STAFF REPORT

REGIONAL CENTER HEARING EXAMINER - HIGH IMPACT CASE

Case Number	2022-REG-067
Address (approx.)	675 East Washington Street
Location	Center Township, Council District # 16
Petitioner	Global Indy III, LLC, by Jamilah Mintze
Zoning	I-3 (RC)
Request	Regional Center Approval to provide for a 10,000-square-foot building addition to an existing 85,000-square-foot building and minor façade improvements. Existing windows, glass block, brick veneer and main entry would remain.

Site plan

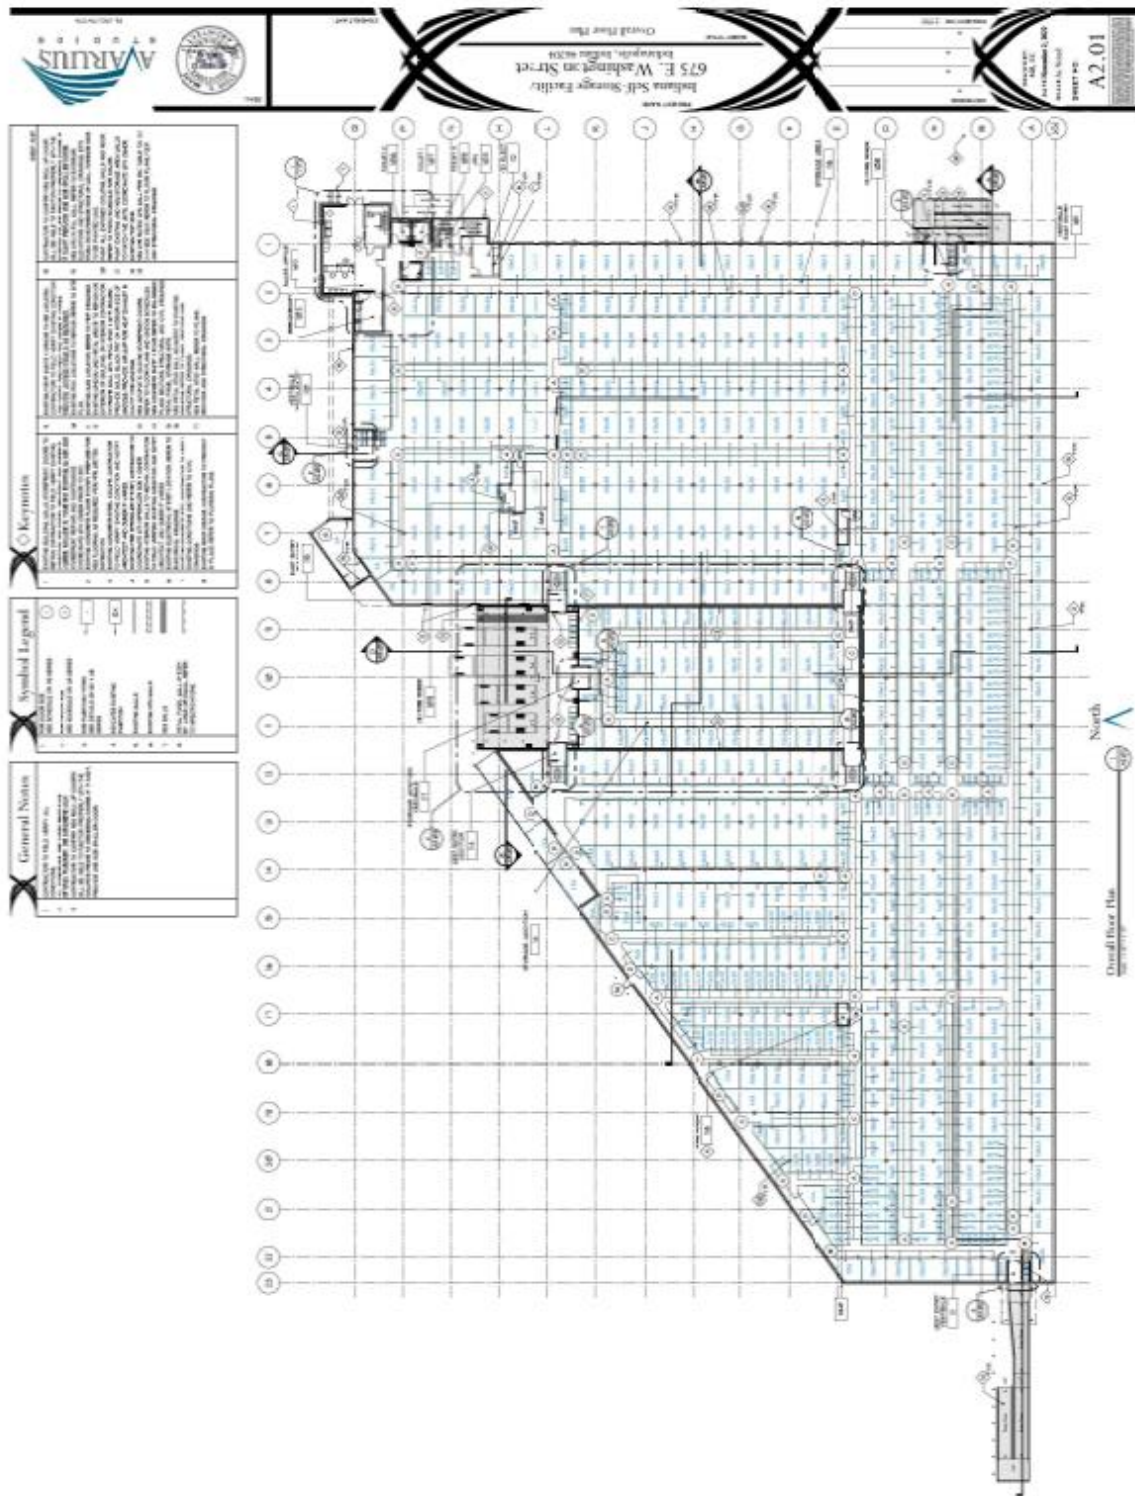
3. A landscape plan was not submitted with this request. Staff proposes that new landscaping be added along College Avenue and at the corner of College Avenue and Washington Street. A landscape plan shall be submitted and subject to planning staff review and approval, prior to the issuance of an Improvement Location Permit. These Guidelines shall be reviewed in formulating the landscape plan: US 1.3.2, SC 3.4.2, CA 4.4.3, CA 4.6.1, CA 4.6.2, and CA 4.6.4.

Elevations

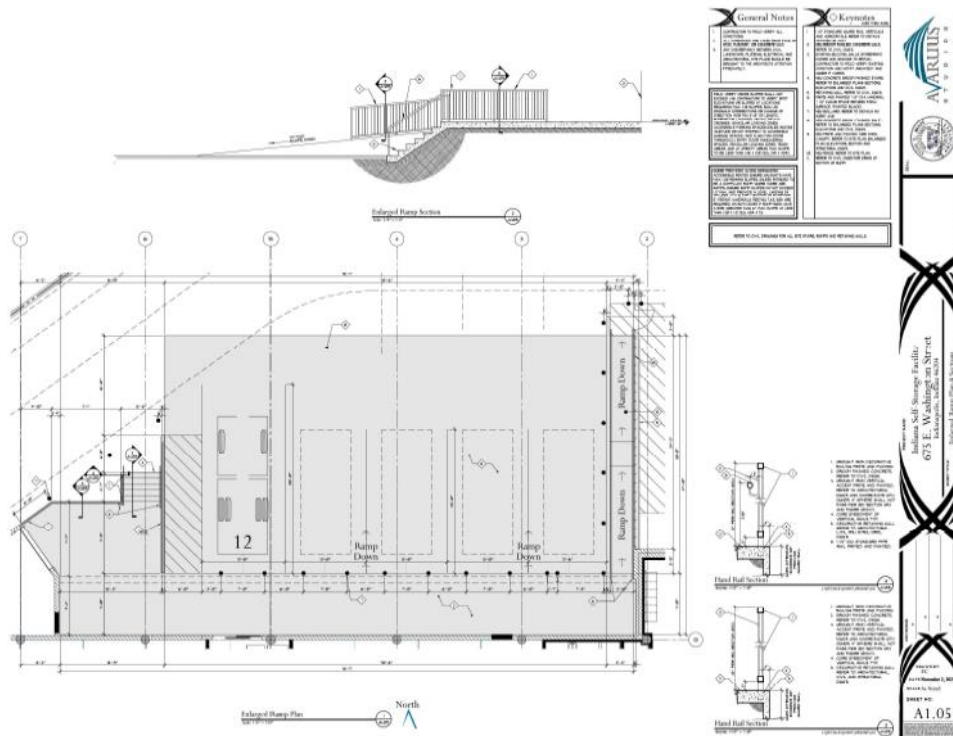
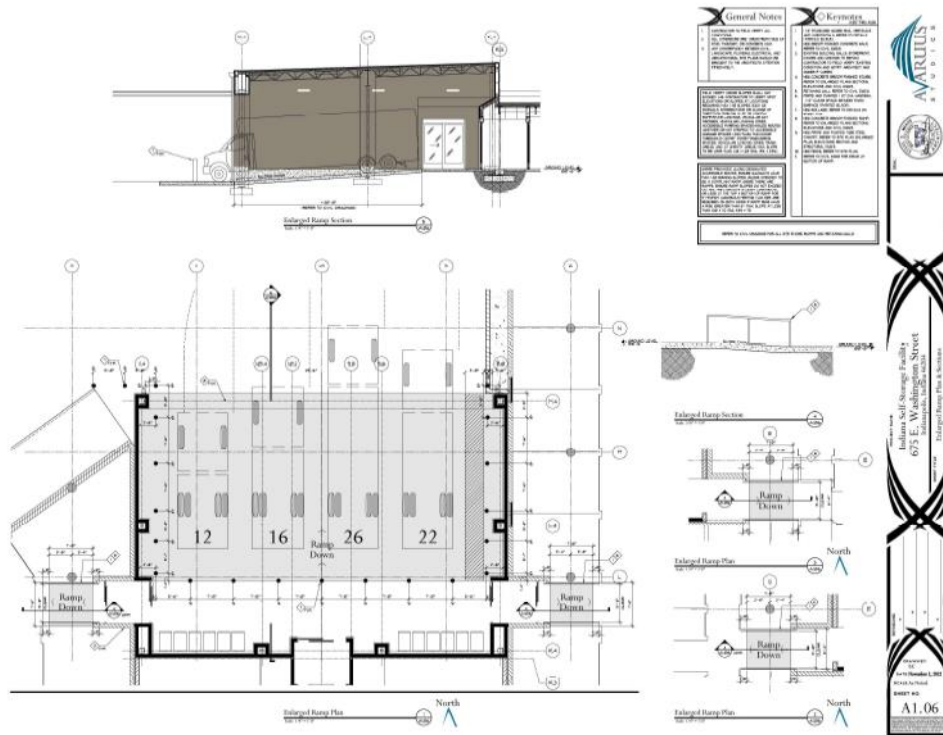
2. The following Guidelines relate to site buffers and building character, including paint colors: US 1.2.1, US 1.2.3, SC 2.1.1, CA 1.2.4, CA 2.1.1, CA 2.1.2, CA 2.2.1, CA 2.2.2, CA 2.3.1, and CA 2.3.4. The existing loading dock on the north side of the building would be visible from College Avenue, especially when trucks are being loaded and unloaded. Staff proposes that a masonry wall be constructed to shield the loading area from view of the public way and that this wall shall be tall enough to shield a typical rental truck. Additionally, the chosen paint color is too bright and should be toned down. Staff proposes that the color of the upper-most brick color on the two-story portion of the building, be used as a guide to finalize a paint color. This paint should also not cover the entire building along the public way. Staff has no issues with using the bright orange color for awnings or canopies. A photo of the brick to use as a guide is below. A revised elevation plan noting the above recommendations shall be submitted and

5. Guidelines CA 2.1.3, CA 2.1.4 and CA 2.4.1 require windows for the commercial use to be a minimum of 59% visible light transmitted through the window along grade level. No new windows are proposed at grade level for this existing building. The building is separated from the public way by an existing paved area. Staff would accept that to meet these Guidelines would require a building addition near the public way, which is not proposed.

subject to planning staff review and approval, prior to the issuance of an Improvement Location Permit.
